■VALVE MECHANISM

1. General

6. Oil Pan

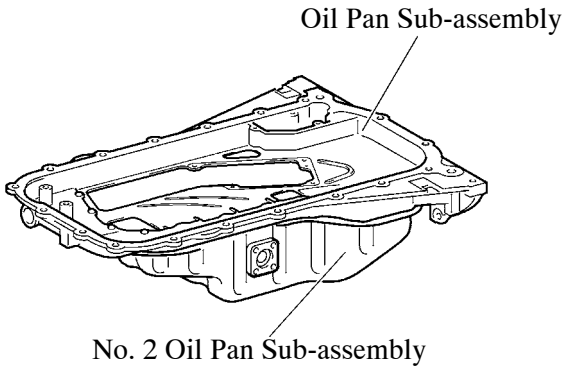
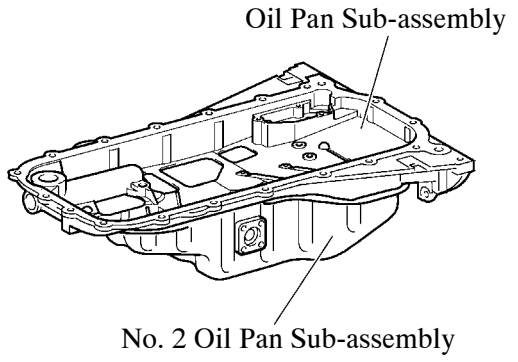
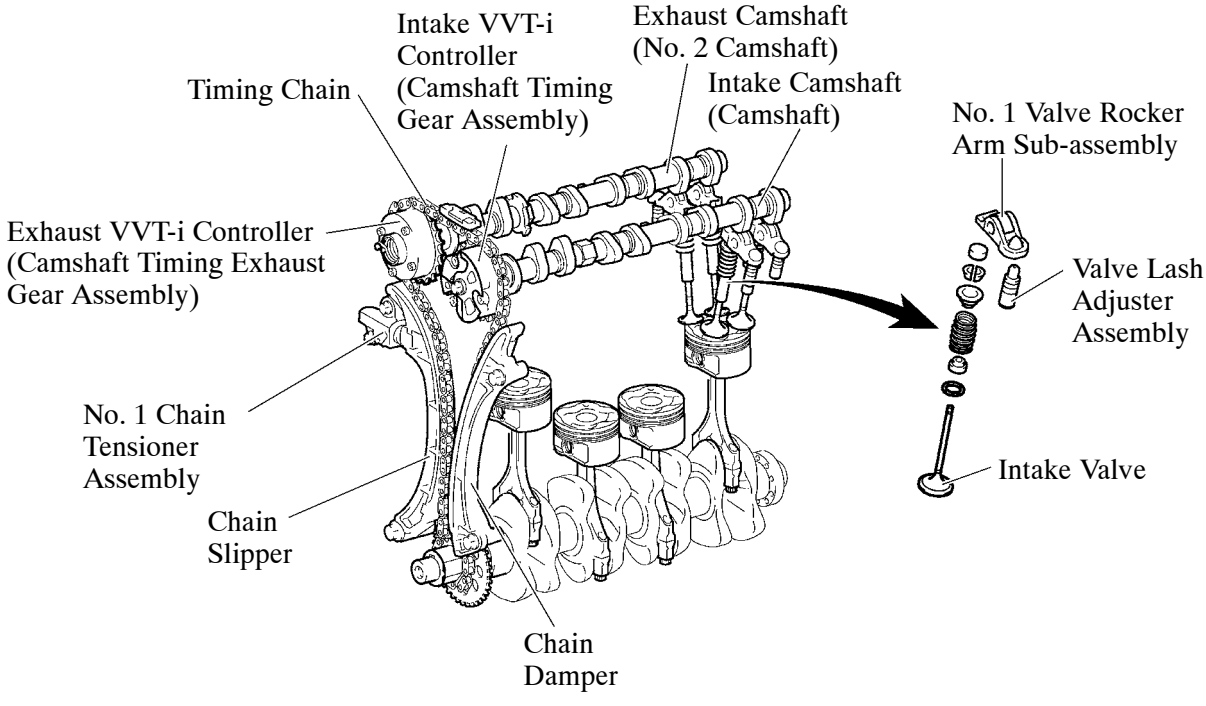
A newly shaped oil pan sub-assembly has been adopted.

2. Camshaft

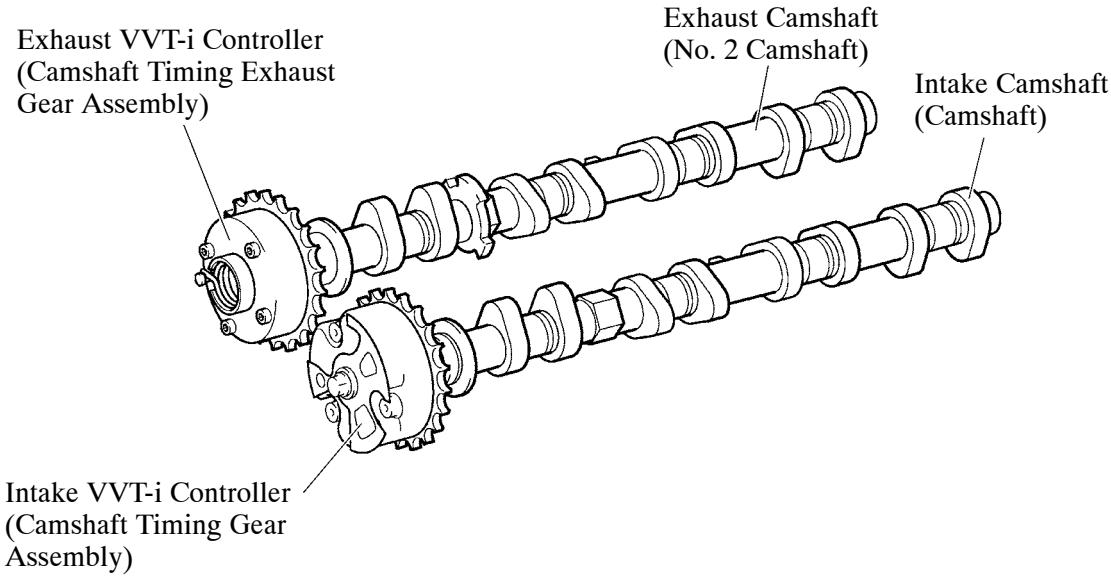
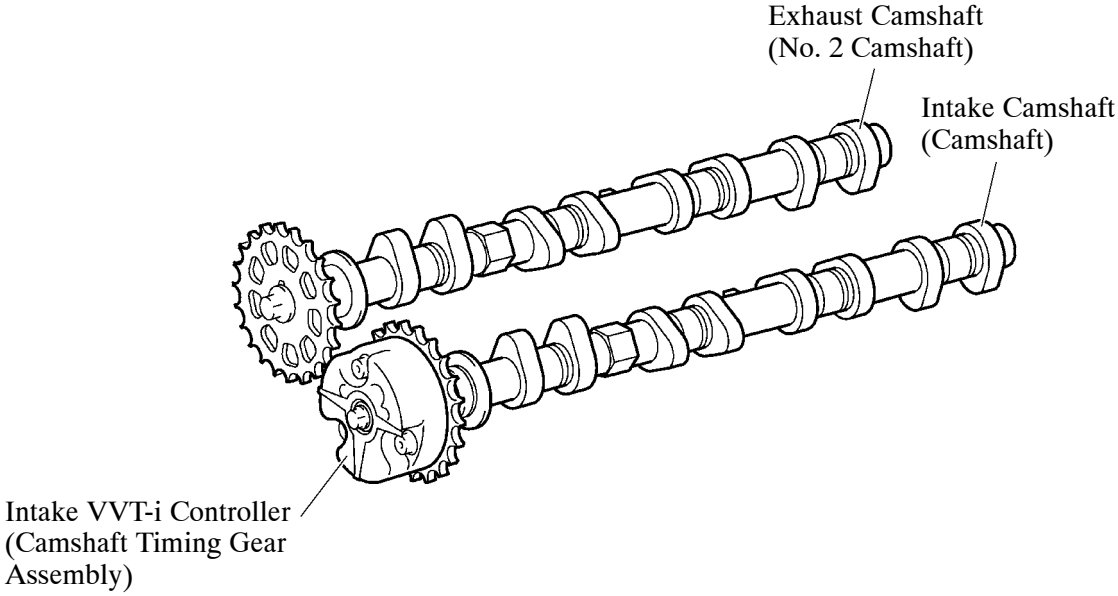
- A VVT-i has been adopted for the exhaust camshaft.
- A newly shaped VVT-i has been adopted for the intake camshaft.

3. Timing Chain and Chain Tensioner

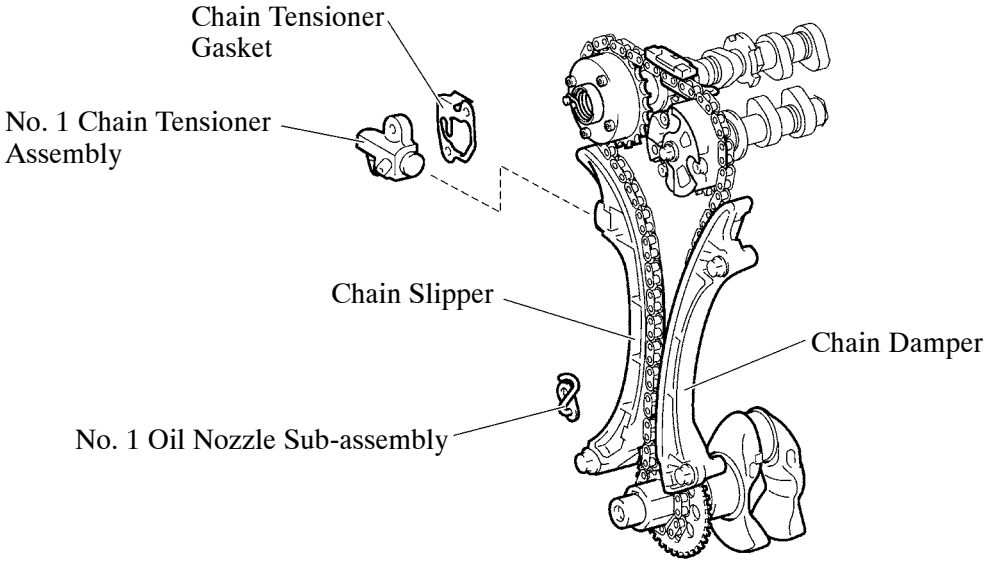
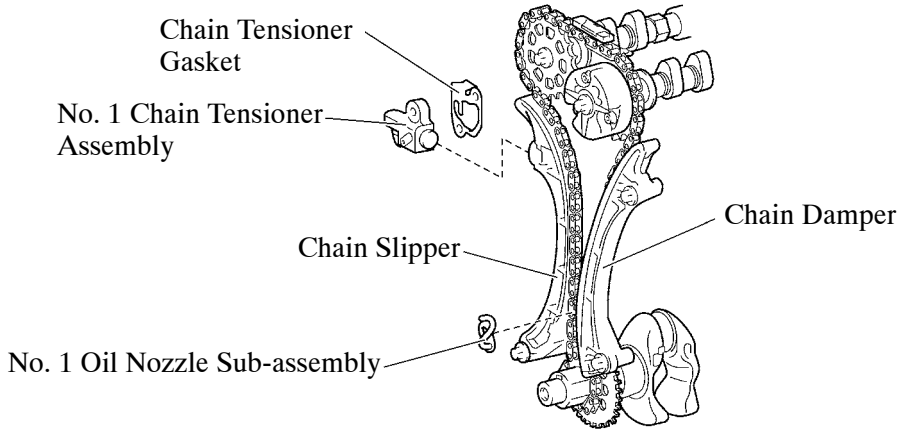
- A VVT-i has been adopted for the exhaust camshaft.
- A newly shaped VVT-i has been adopted for the intake camshaft.

4. Timing Chain Cover

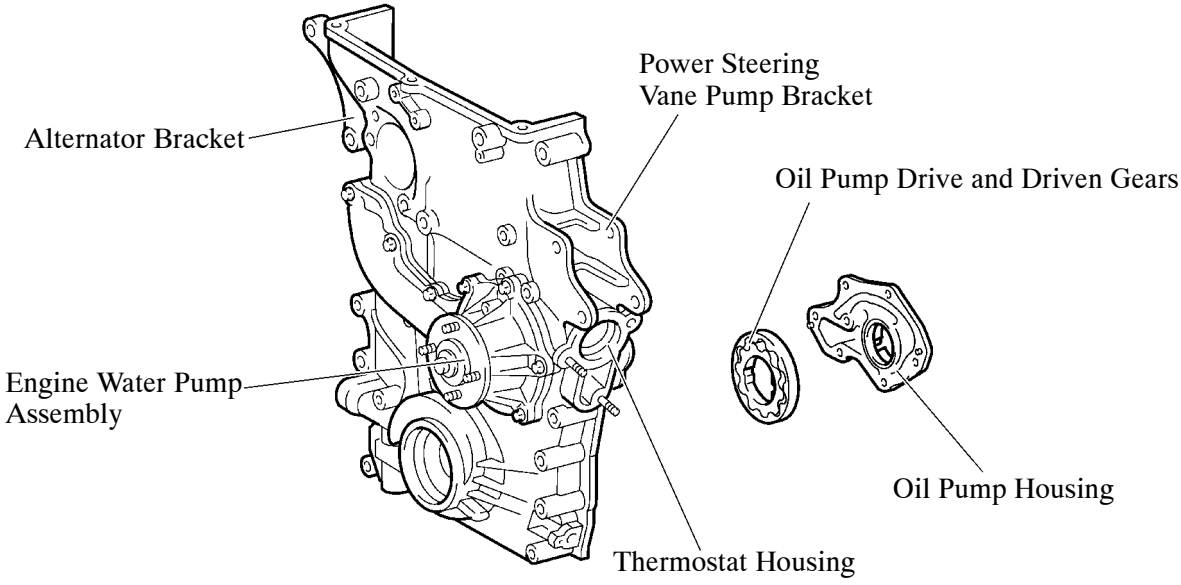
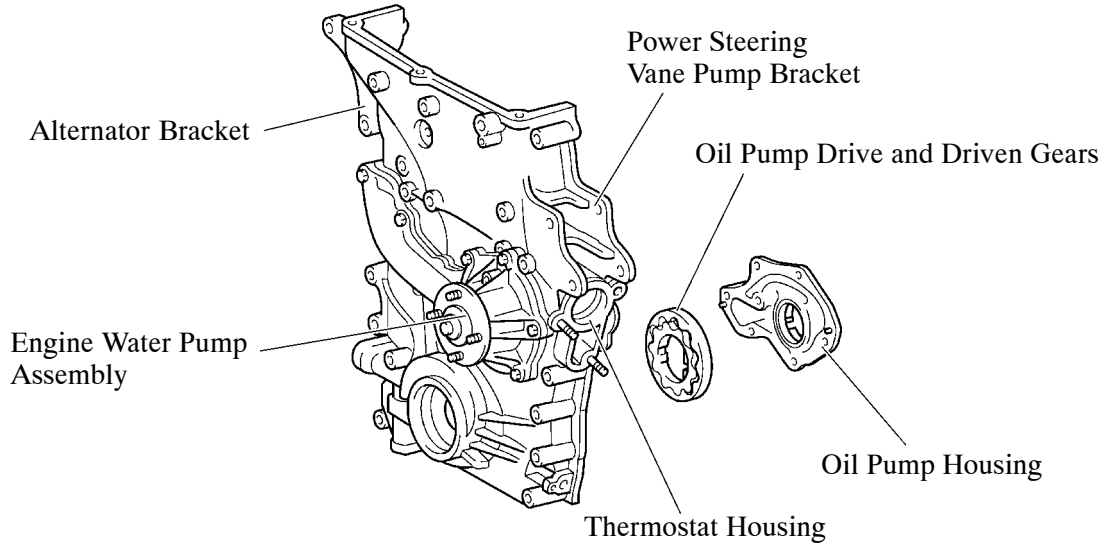
A newly shaped chain or belt cover sub-assembly has been adopted.
